# STAFF REPORT

**CASE NUMBER:** PD 17-11  
**L.U.C.B. MEETING:** August 10, 2017  
**LOCATION:** 6610 Messick Road  
**OWNER/APPLICANT:** Emmanuel United Methodist Church / Kircher-Uhlhorn Development LLC  
**REPRESENTATIVE:** W.H. Porter Consultants PLLC  
**REQUEST:** Residential single-family planned development  
**AREA:** +/-7.06 acres  
**EXISTING ZONING:** Residential Single-Family – 15 (R-15)

**SITE PLAN**

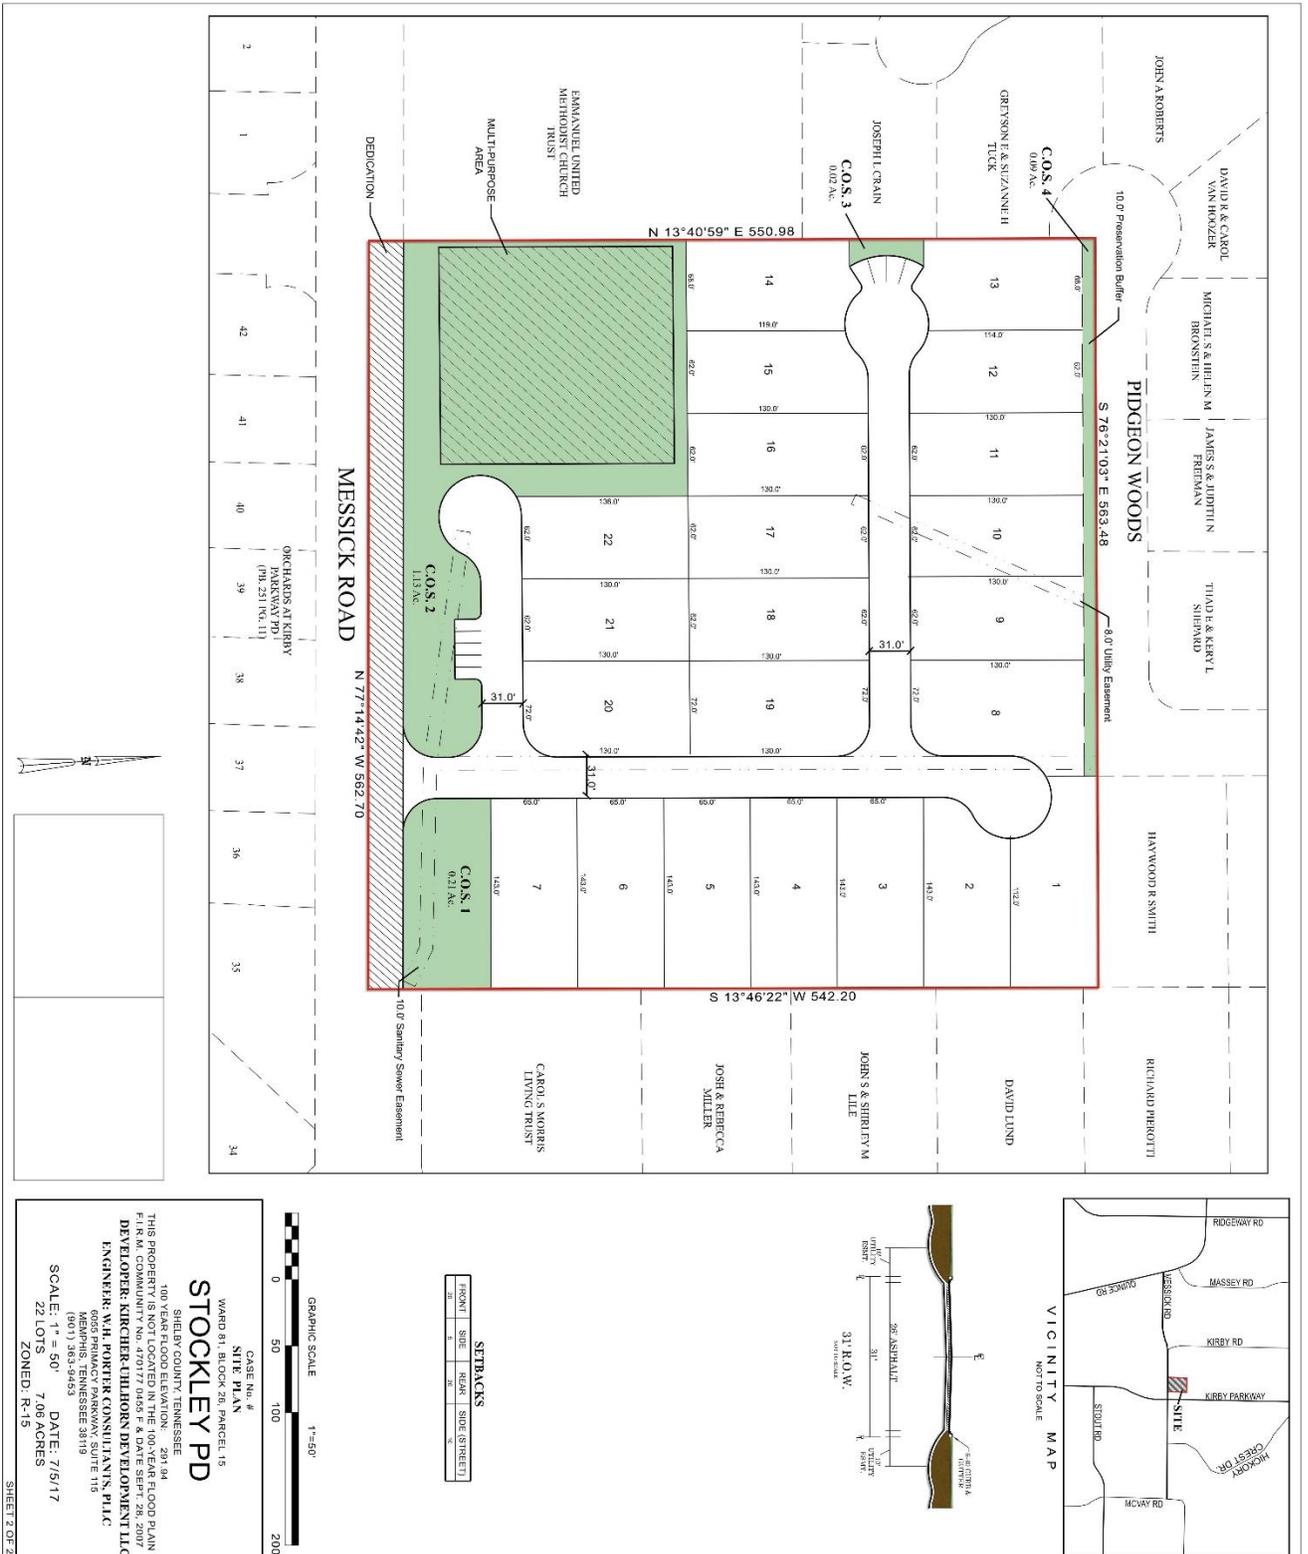
11. Provide cul-de-sac radii on all streets.
12. Identify the drives as "Private."
13. Set aside guest parking areas.
14. All private drives/rear service drives shall be constructed to meet pavement requirements of the Subdivision Regulations, applicable City Standards, and provide a minimum width of twenty-two feet (22')/eighteen (18) feet.

24. Provide internal circulation between adjacent phases, lots, and sections. Common ingress/egress easements shall be shown on the final plats.
25. All parking areas and driving aisles to be paved with asphalt or concrete.
26. Adequate queuing spaces in accordance with the current ordinance shall be provided between the street right-of-way line and any proposed gate/guardhouse/card reader.
27. Adequate maneuvering room shall be provided between the right-of-way and the gate/guardhouse/card reader for vehicles to exit by forward motion.
